**CHARTER TOWNSHIP OF VAN BUREN  
PLANNING COMMISSION AGENDA  
Wednesday, December 14<sup>th</sup>, 2022 – 5:30 PM  
Van Buren Township Hall  
46425 Tyler Road**

**ITEM # 1: ZONING ORDINANCE TEXT AMENDMENTS – RESIDENTIAL ZONING REGULATIONS**

**ITEM # 2: 5M VAN BUREN LLC / INTEGRITY COMPONENT AND DESIGN – SPECIAL LAND USE REVIEW**

PROJECT MANAGER: - C:\PW\_WORK\WADE-TRIM\_VCLARK\01129952\PLTS-EGLE CONSERVATION EASEMENT PLANDWG - C2.0 - PLOTTED 11/22/2022 8:23 AM BY CLARK, VERONICA

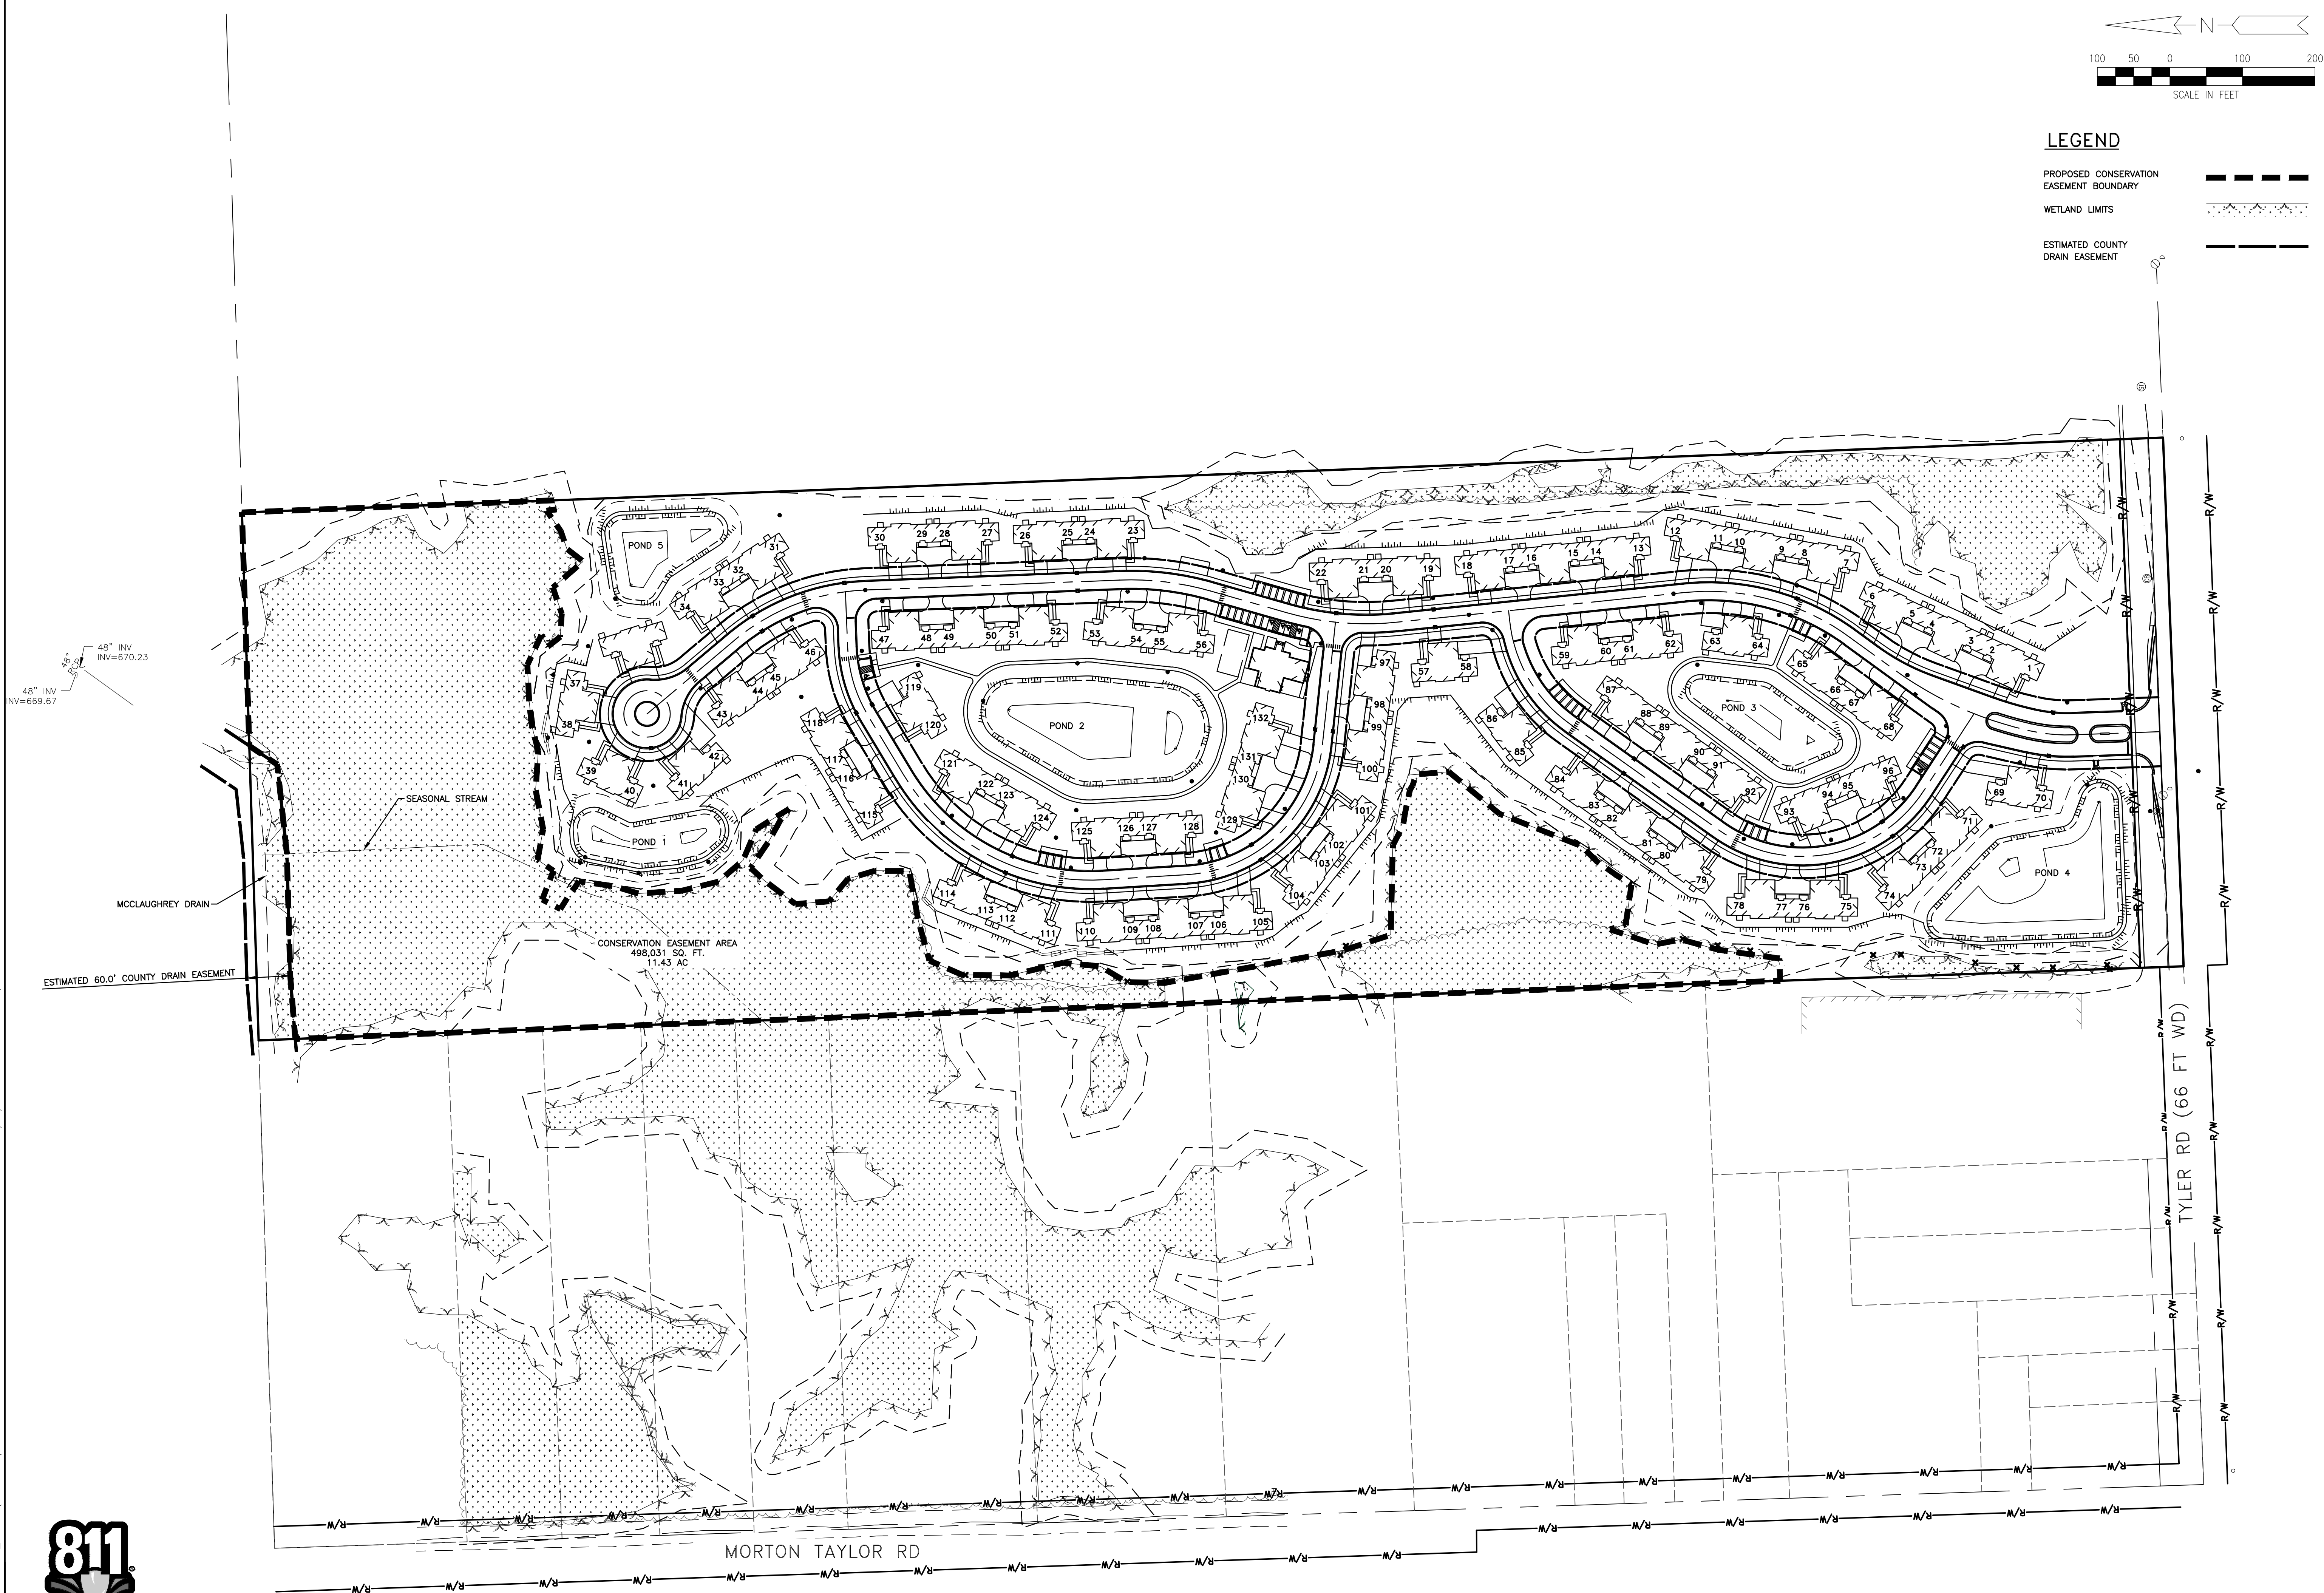
1. We'll stand by for any additional information you have regarding your proposed conservation easement. The comments received last night complement the project's preservation of and lack of disturbance to the wetlands on the project's north end. In the meantime, please familiarize yourself with the Township Engineer's comments on water and sanitary, among his other comments. We'll look to your team for a proposal on the funding mechanism for the long-term maintenance of the proposed pump station that we can review.

*Response: We sent Dan Power a proposed DRAFT conservation easement on November 22, 2022. We will be working with EGLE and the Township to finalize the conservation easement. We will be sure to familiarize ourselves with the Township Engineer's comments on water and sanitary sewer, among his other comments. We will propose a funding mechanism for the long-term maintenance of the proposed pump station for your review during the engineering stage of the review.*

Van Buren Township, MI  
Menards Site Landscape Plan  
February 27, 2020  
Scale: 1" = 60'-0" CT2

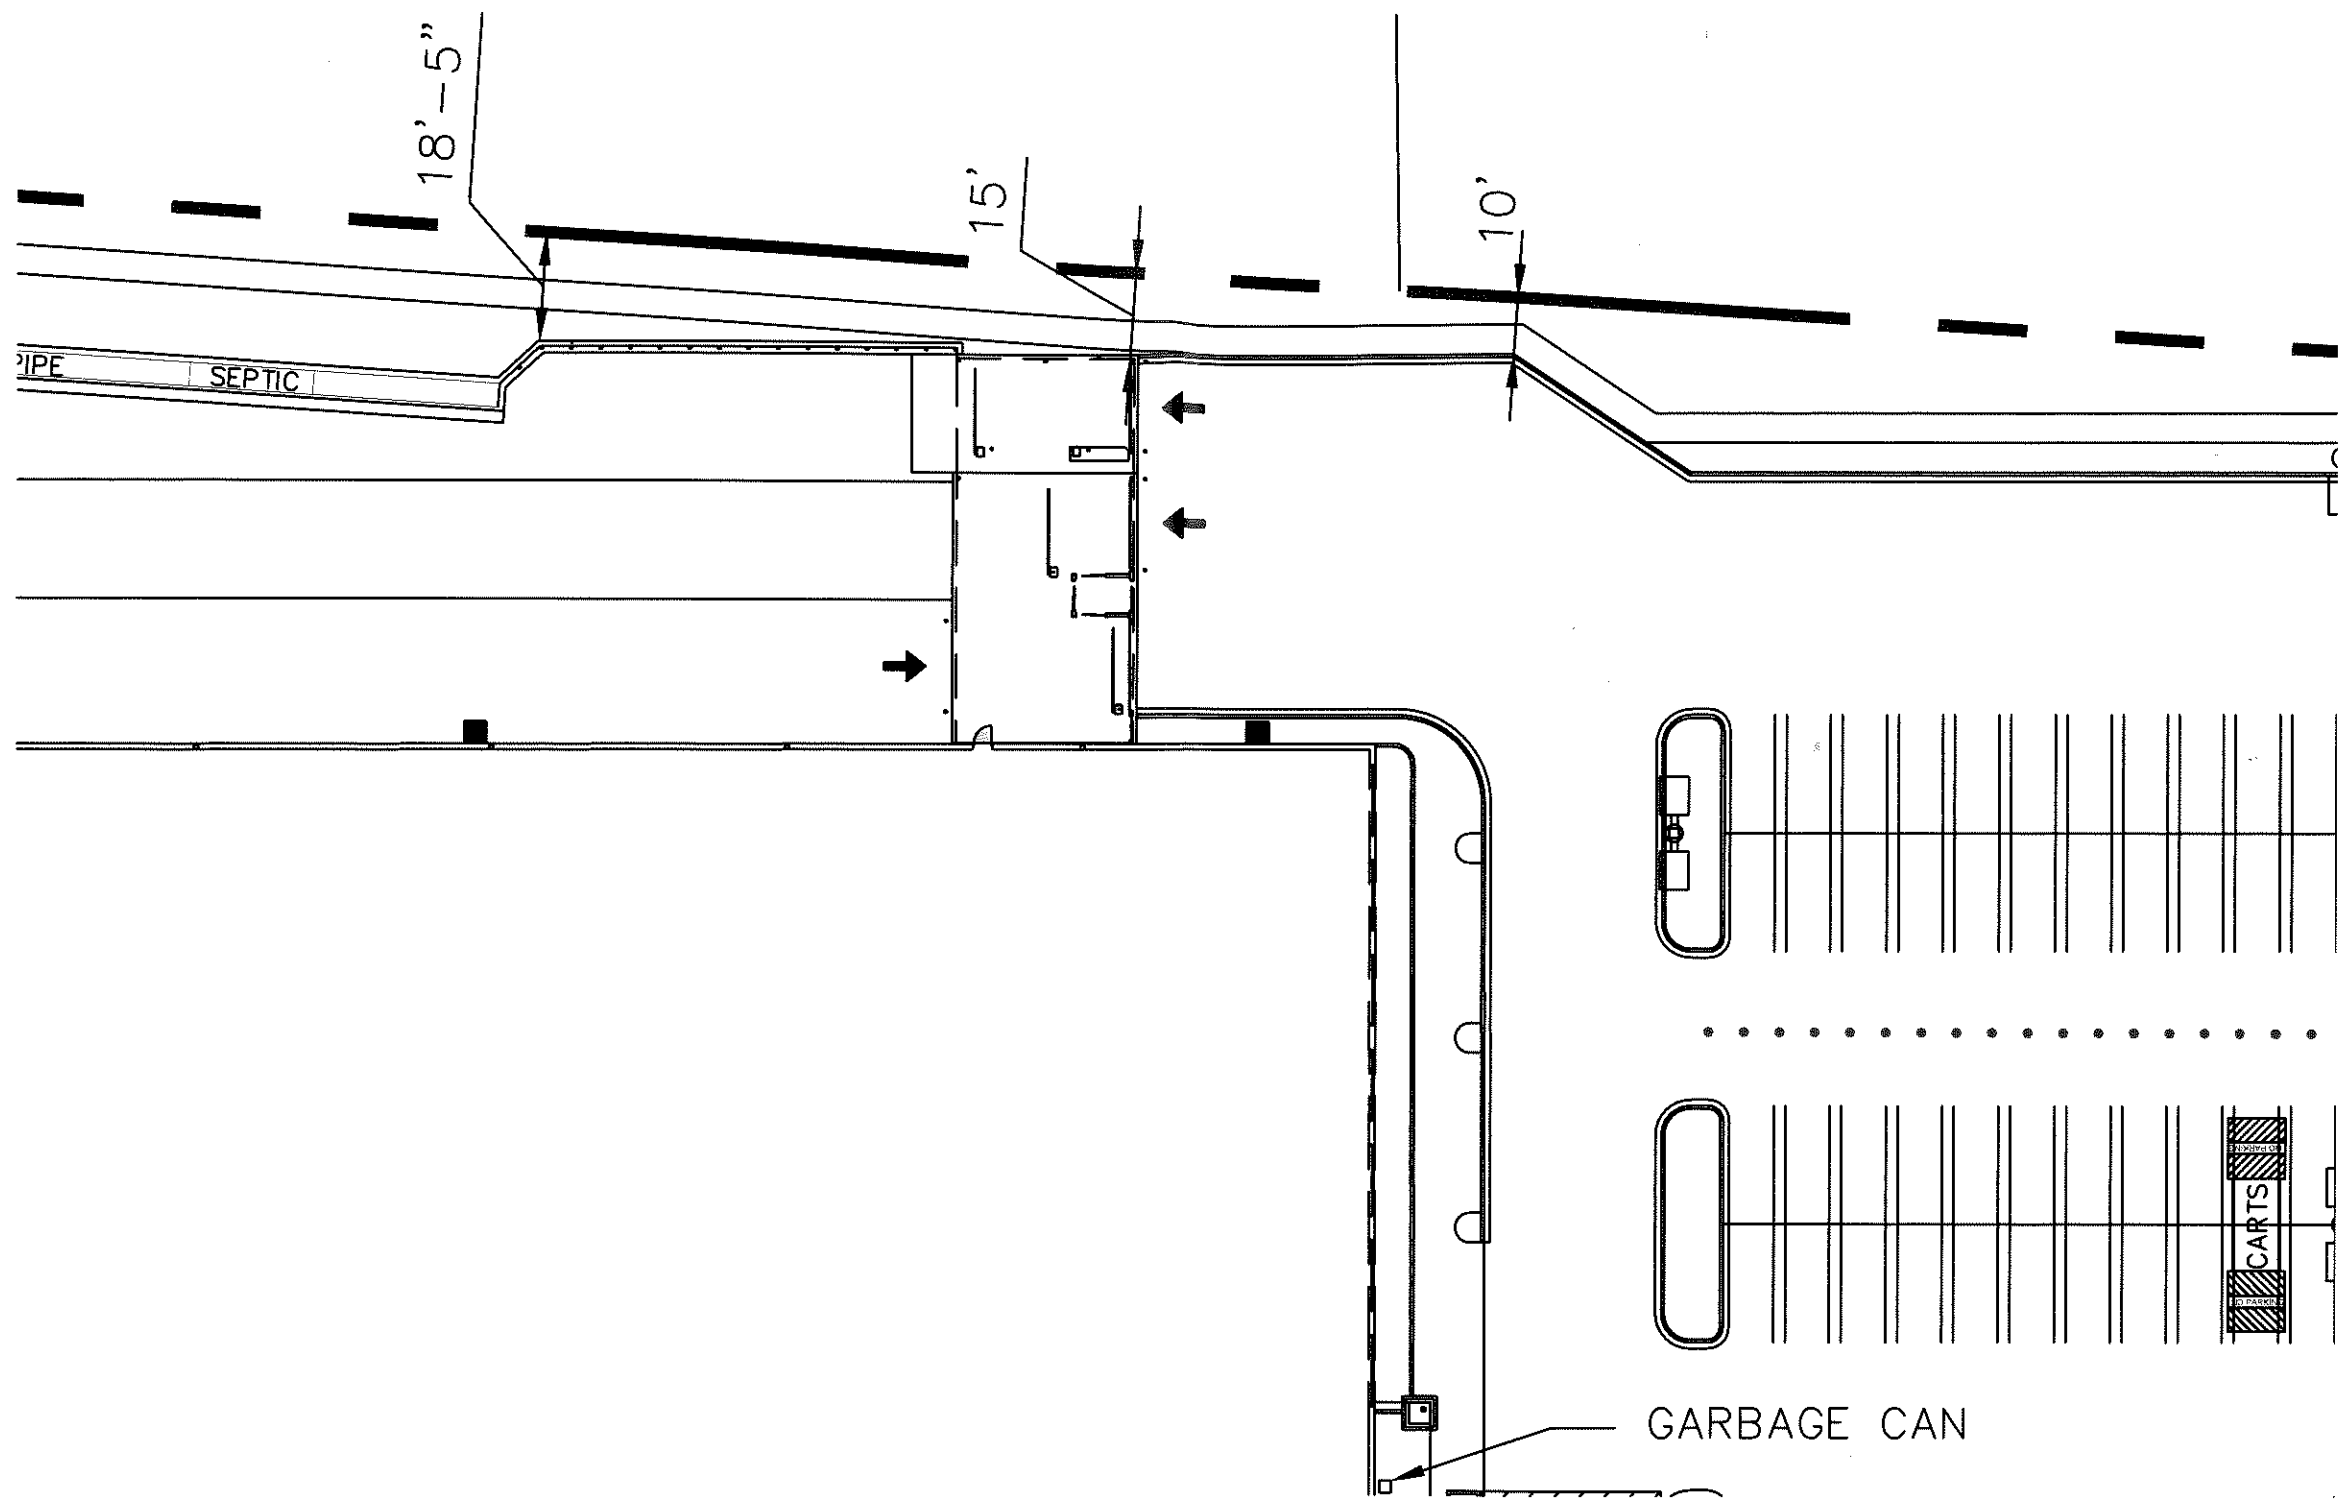
In July 2022, the applicant submitted a building permit application which included additional details regarding the request, including a detail 1/CT2 which demonstrates that the proposed addition includes a canopy with columns and an overhead door, which constitutes an attached accessory structure. This attached accessory structure is subject to the setback requirements of the Van Buren Township Zoning Ordinance, which includes a 25-foot side yard setback. This important distinction led to the specific variance item / zoning deficiency around the building setback which would not apply to a fence or gate. As a result, the applicant is seeking a variance at the next available opportunity from the Van Buren Township Board of Zoning Appeals (BZA).
